Red Clay Consolidated School District
AI DuPont Middle School HVAC Renovations
Bid Pac "A"

ADDENDUM #1 ISSUED BY EDiS COMPANY
110 S. POPLAR STREET, WILMINGTON, DE 19801

PARTIAL FIRST FLOOR RCP DEMOLITION PLAN - AREA B - A/2.10

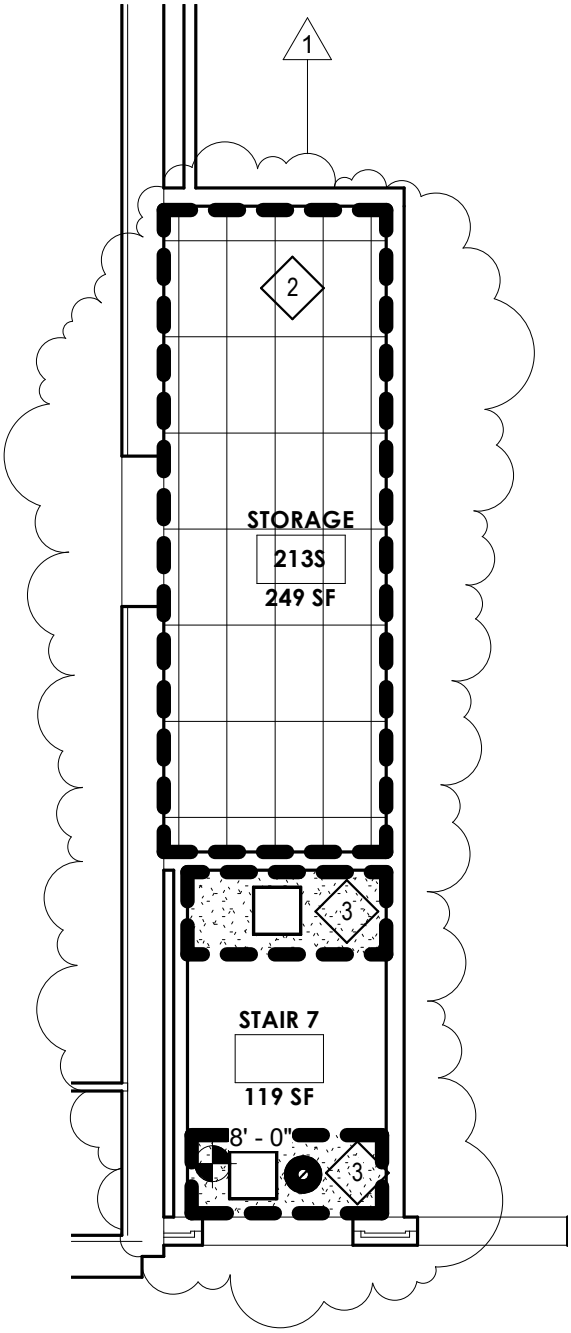
24. Drawing A2.10 – Add demolition of existing ceiling finishes to scope of work in Storage 213S and Stair 7. See sketch SK-A.22.
25. Drawing A3.10 – Add new ceilings to scope of work in Storage 213S and Stair 7. See sketch SK-A.23.
26. Drawings A3.4 & A3.6 – Provide masonry infill at existing chimney where demolition occurs for MEP access. See sketch SK-A.24.
27. Drawing A6.4 – Typical Wall Infill Detail added. See sketch SK-A.25.

PARTIAL MECHANICAL ROOF PLAN

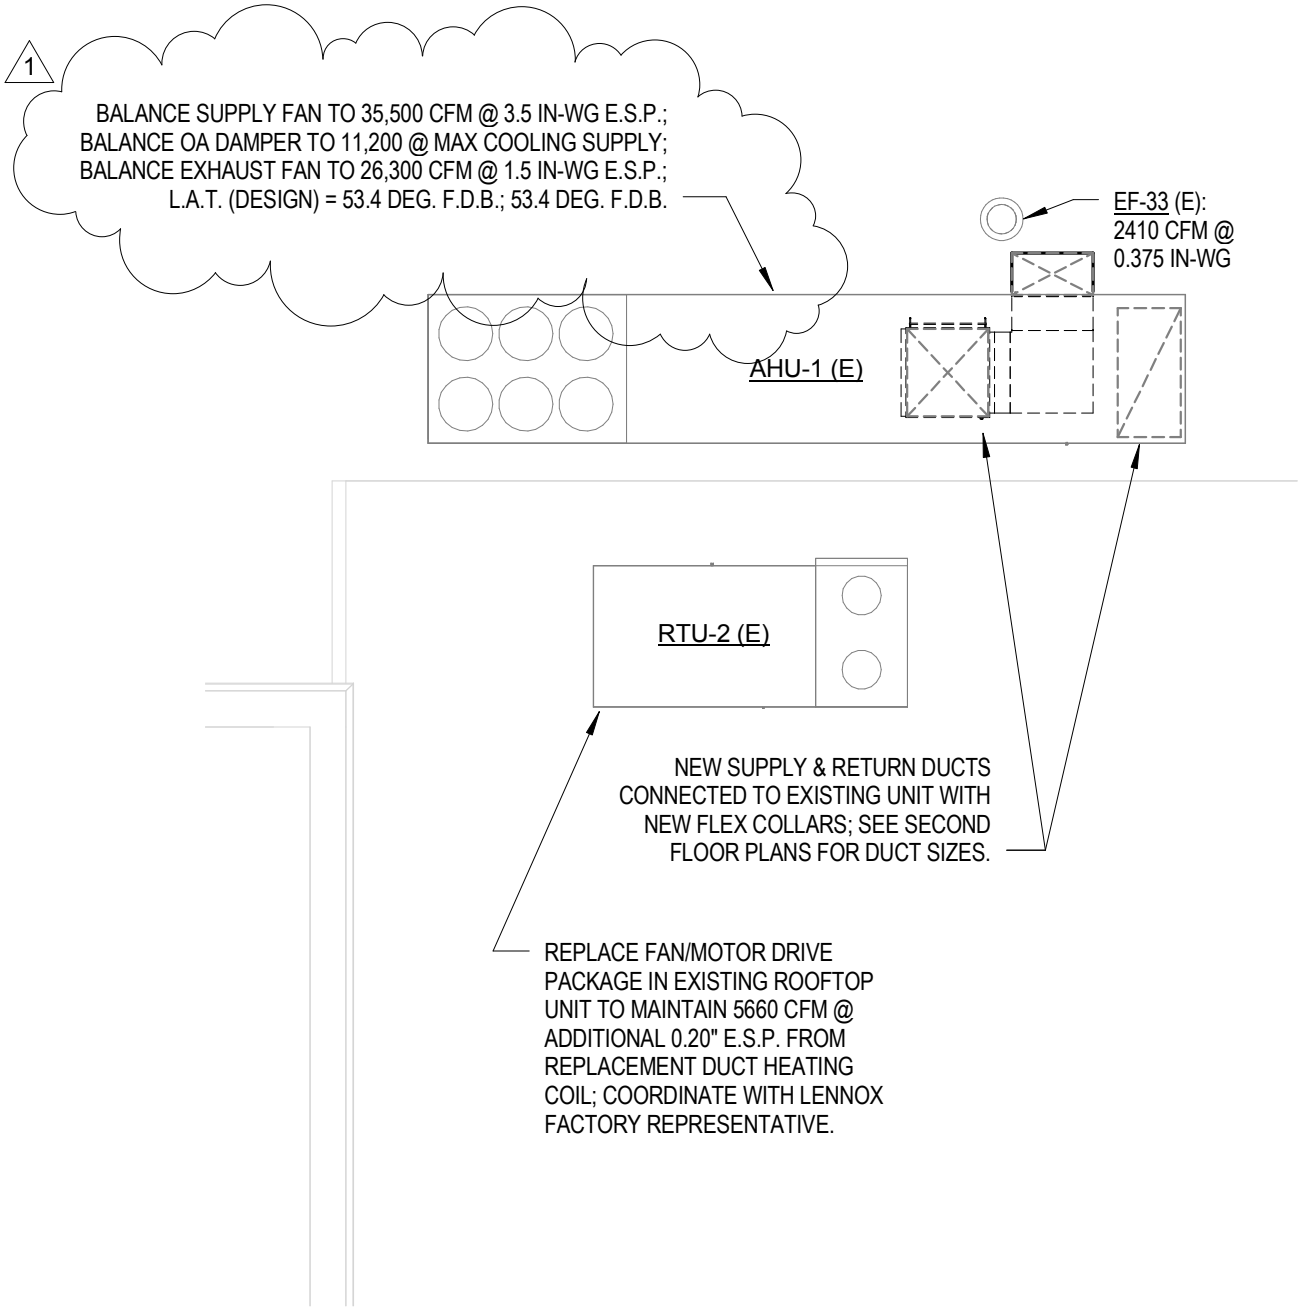
2. Drawing M8.26 – Add TAB scope of work for AHU-1; See sketch SK-M.1.
3. Drawing M8.26 – Add note to read "Existing exhaust fans EF-42 and EF-50 are to be interlocked with OA damper at AHU-5. No sketch issued to reflect this change.

PARTIAL SECOND FLOOR MECHANICAL PLAN

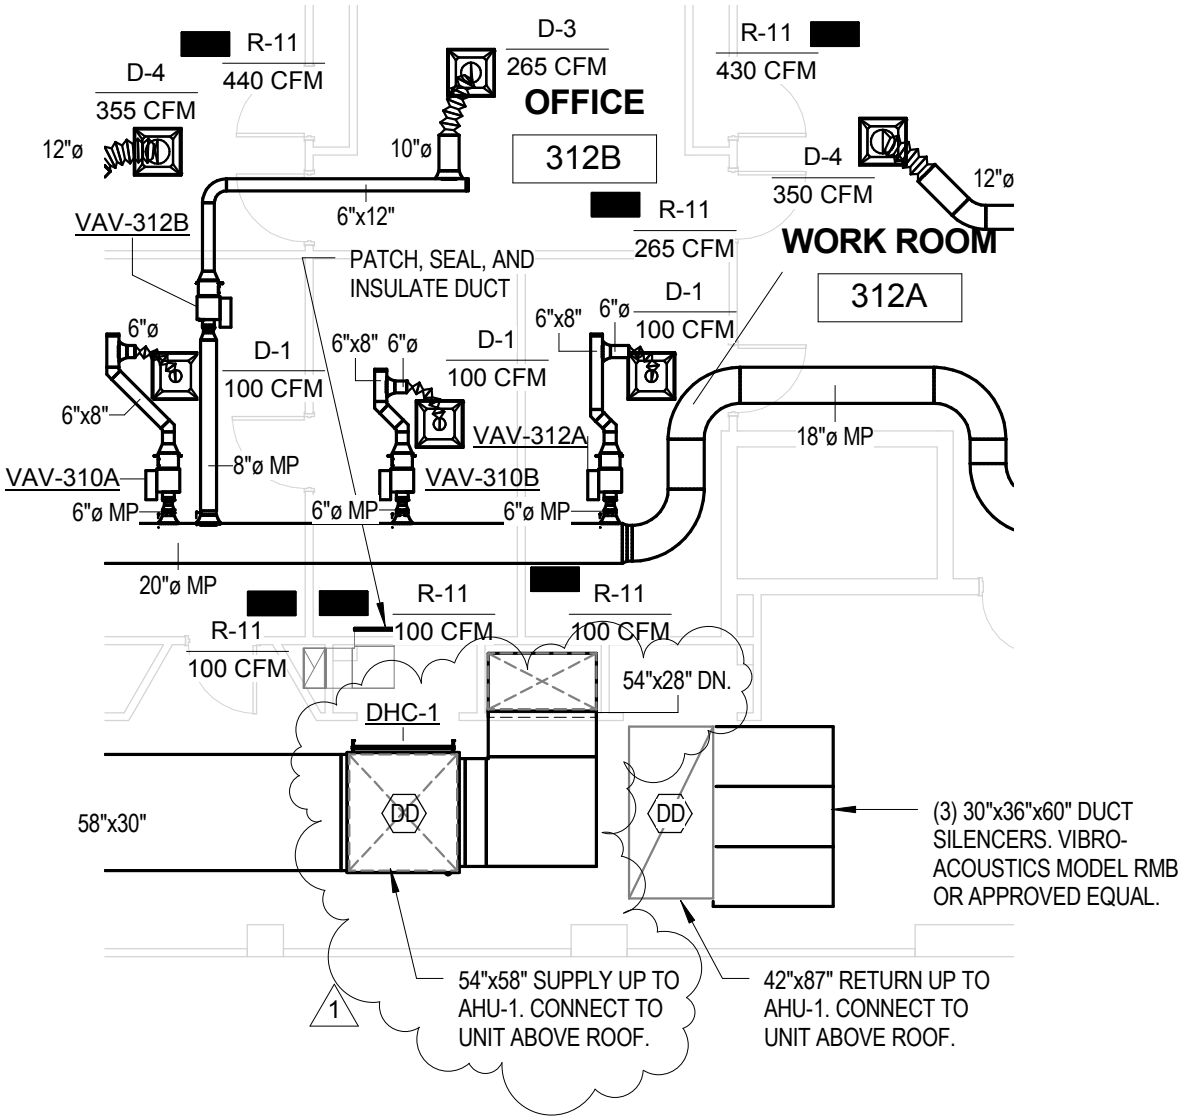
4. Drawing M8.18 – Revise Supply riser to AHU-1 to 54"x58", move duct detector to main trunk up to AHU, and add hot water duct coil DHC-1. See sketch SK-M.2.

PARTIAL SECOND FLOOR HYDRONIC PLAN

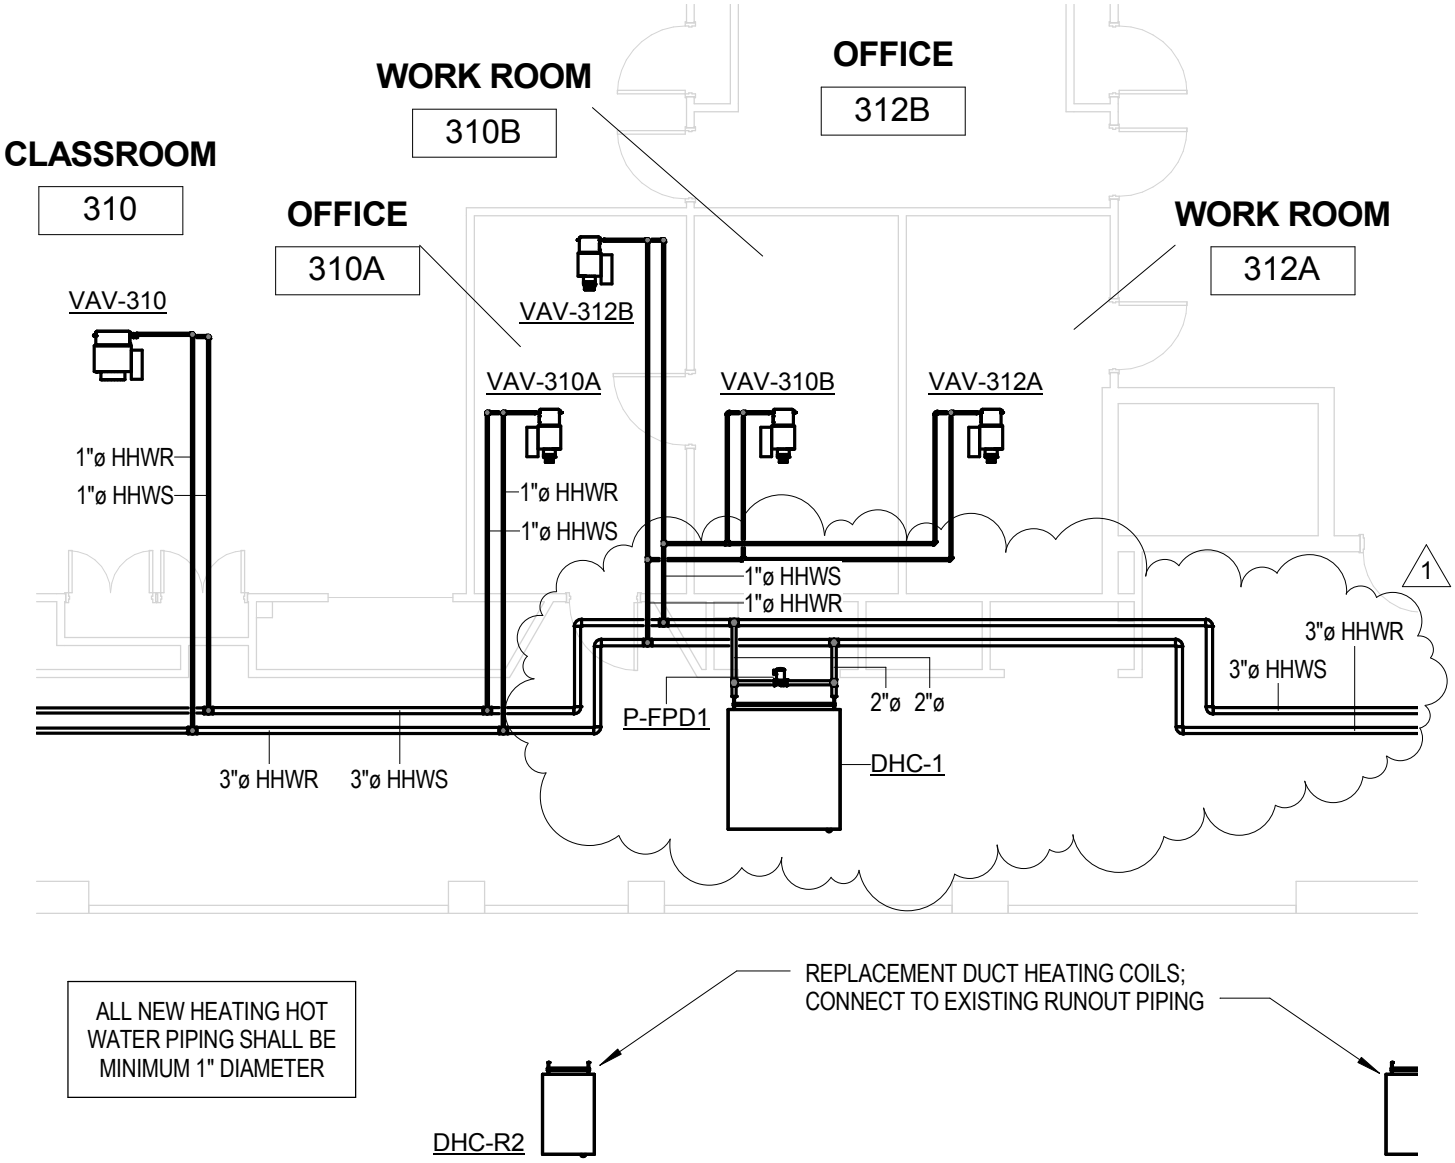
7. Drawing M8.24 – Add freeze protection pump (P-FPD1) to DHC-1, and add piping to DHC-1 as shown. See sketch SK-M.5.
8. Drawing M8.30 – Add boiler room HVAC section view. See sketch SK-M.6.

PARTIAL ENLARGED BOILER ROOM PLAN

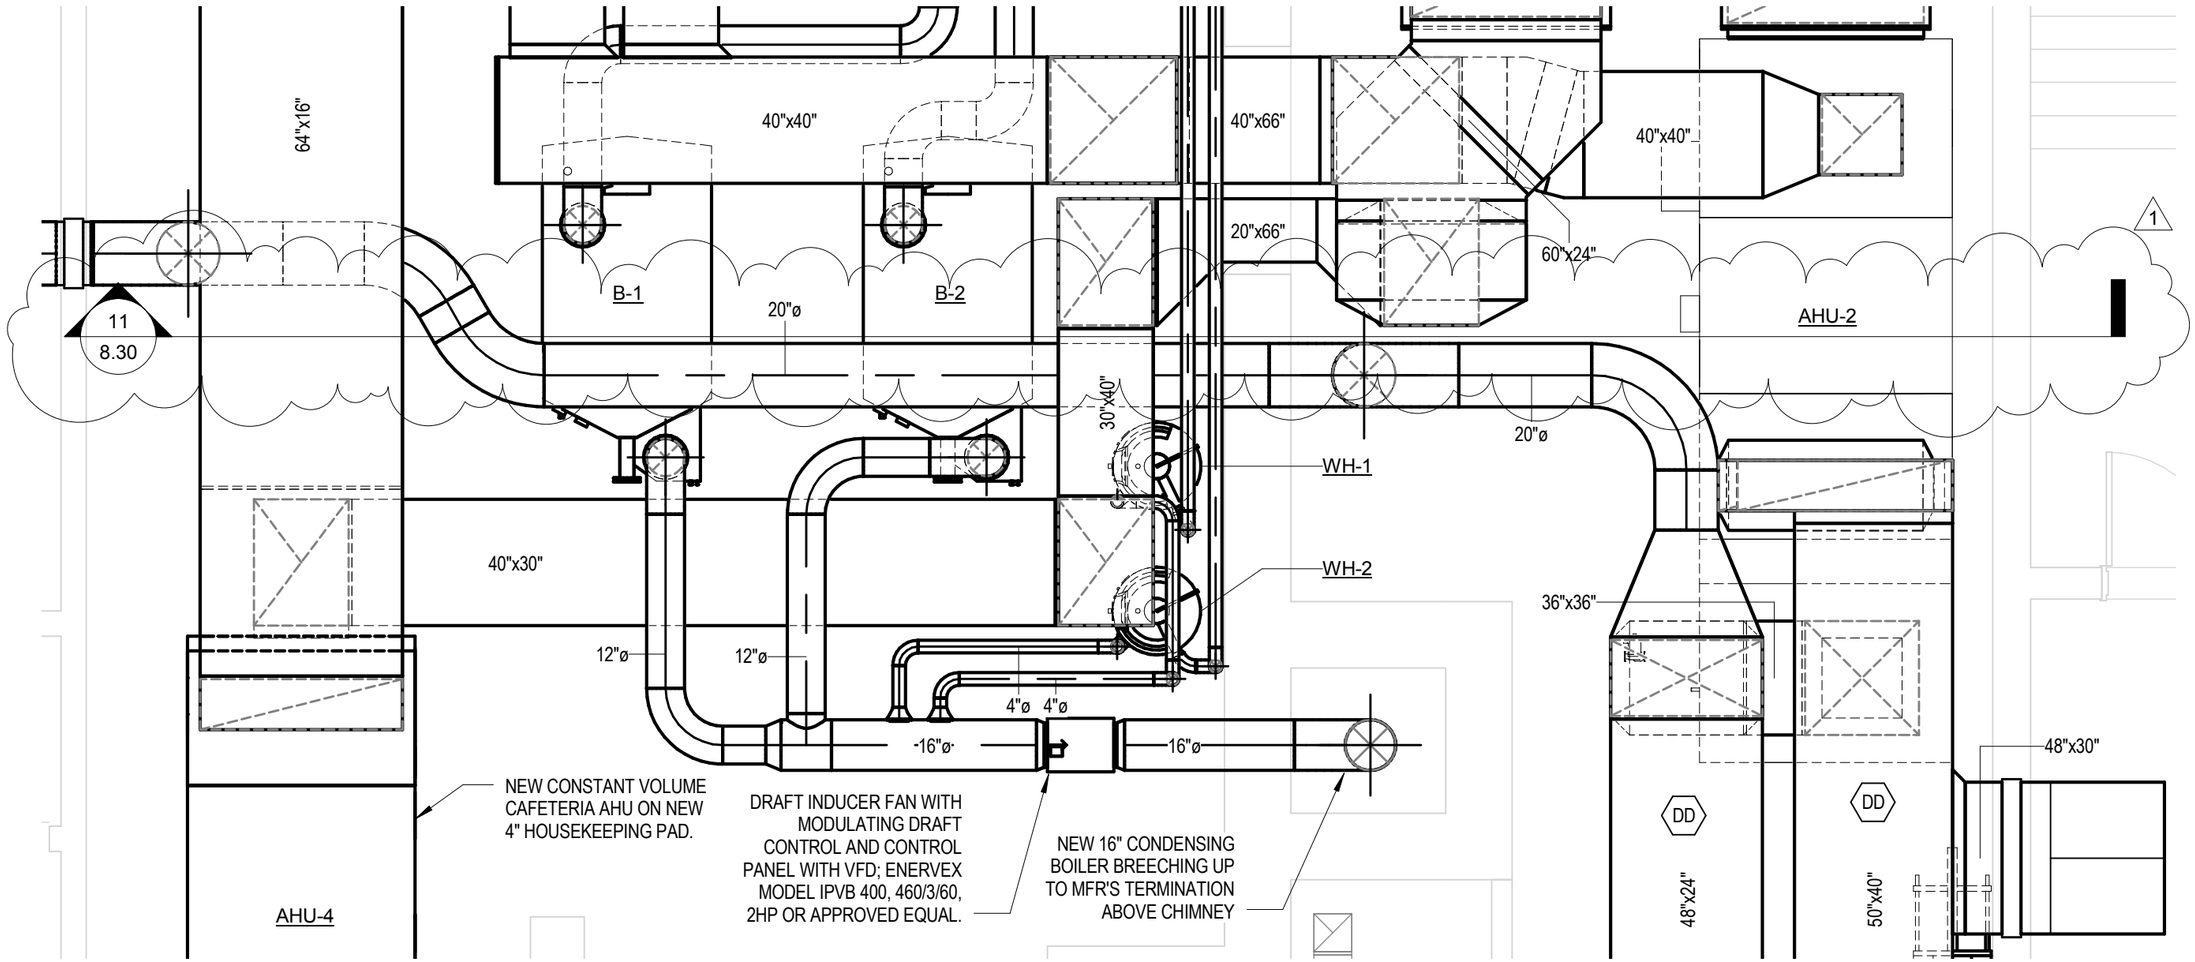
9. Drawing M8.27 – Add section marker for HVAC section view. See sketch SK-M.7.
10. Drawing M8.28 – Add requirement to schedule notes for Air Handling Unit Schedule that units are to be provided with mixing boxes. No sketch issued to reflect this change.

PARTIAL SECOND FLOOR MECHANICAL PLAN

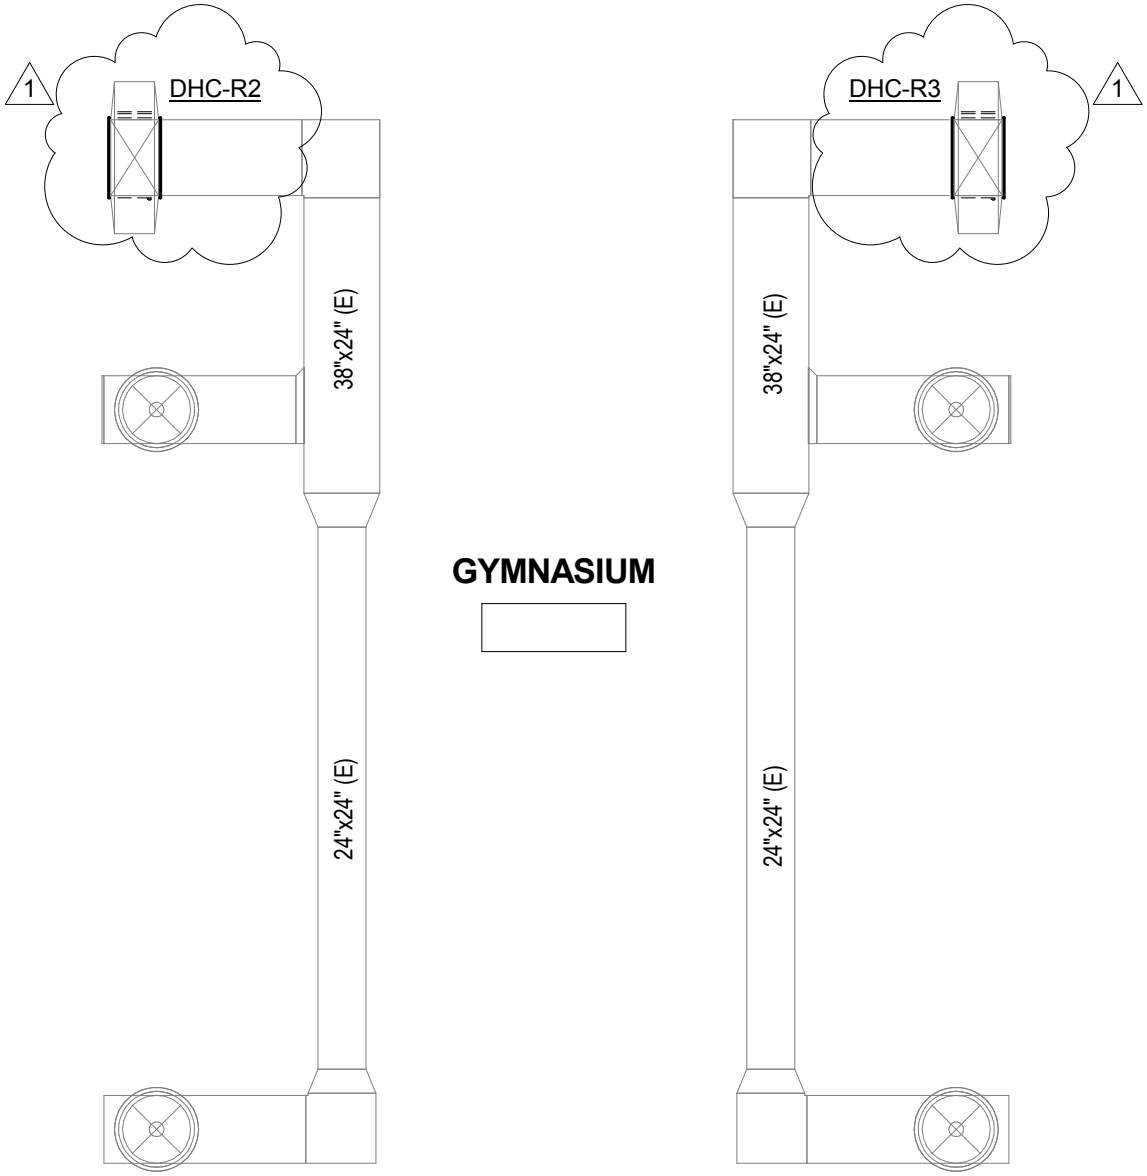
14. Drawing M8.28 – Revise Pump Schedule. See sketch SK-M.8.
15. Drawing M8.18 – Add duct heating coils DHC-R2 and DHC-R3 to replace existing hot water heating coils. Existing hot water heating coils are to be demolished and associated piping accessories are to be demolished. See sketch SK-M.9. Coils are to be connected to existing piping with new 1-1/2" runout piping.

FIRST FLOOR HYDRONIC PLAN - SK-M.10

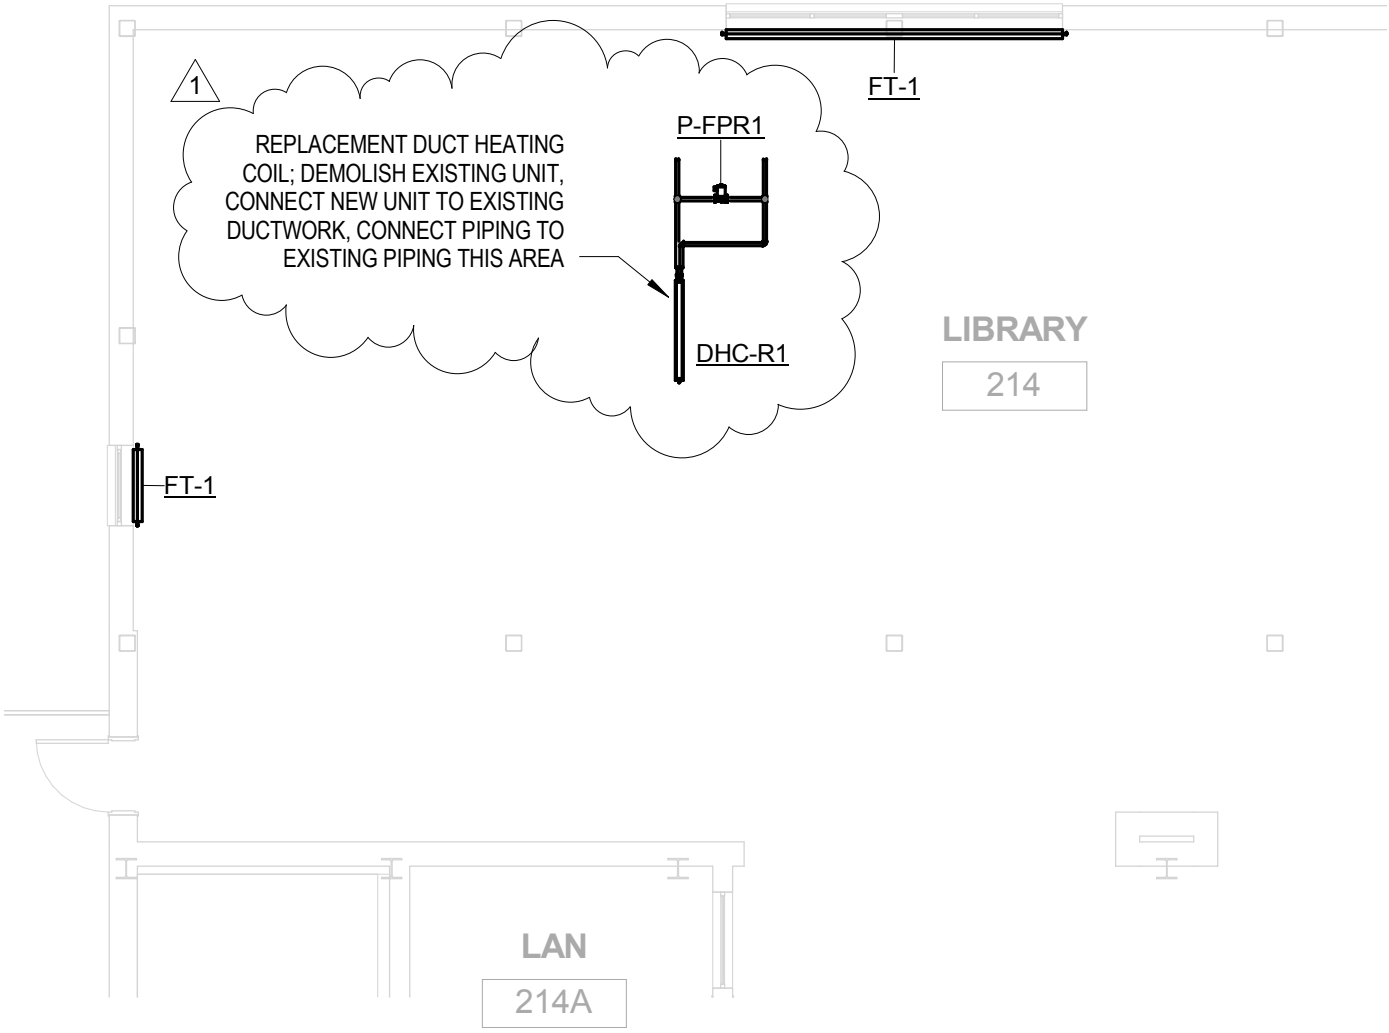
16. Drawing M8.23 – Add duct heating coil DHC-R1 with freeze protection pump P-FPR1 to replace existing hot water coil. Existing hot water heating coil is to be demolished and associated piping accessories are to be demolished. See sketch SK-M.10. Coils are to be connected to existing piping with new 1-1/2" runout piping.
